C1980007, West Elk Mine, September Inspection Report

INSP-REPORTC_C1980007_LDS_09152023045049.pdf

Permit Number: C-1980-007 Mine Name: West Elk Mine Operator: Mountain Coal Company, LLC Operator Address: Ms Nicki Poulos	County: Delta, Gunnison Operation Type: Underground Permit Status: Active Ownership: Private	
5174 Highway 133	Operator Representative Present:	
Somerset, CO 81434	Sperator representative resent	
Somerset, CO 81434	None	
Operator Representative Signature: (Field Issuance Only)

Figure 15: Ditch beside Sylvester Gulch materials storage area needs maintenance

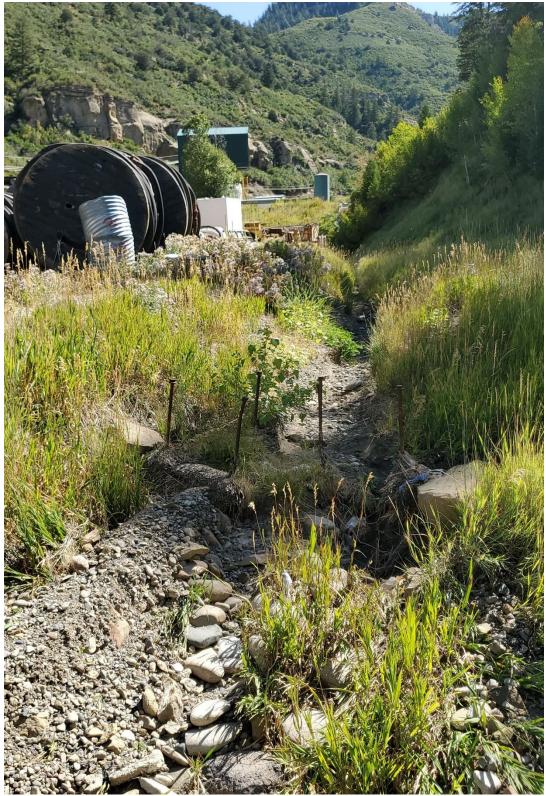
The ditch on the south side of the main Sylvester Gulch facilities area (DSG-1) and the sediment trap at the western end of the ditch were both in need of maintenance, (see figures 15 and 16).

Figure 19: RPE pond (west)

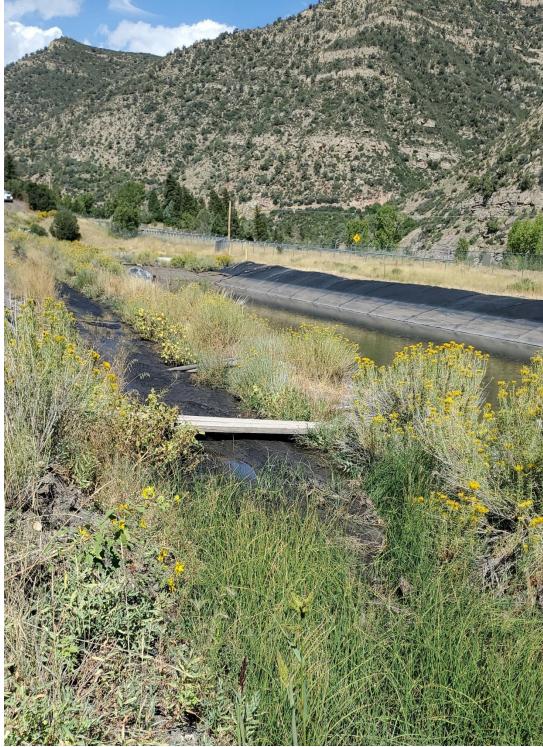
The ditch leading to the RPE ponds, beside the access road (DRPE-2) was in need of maintenance (see figures 18, 19 and 20).
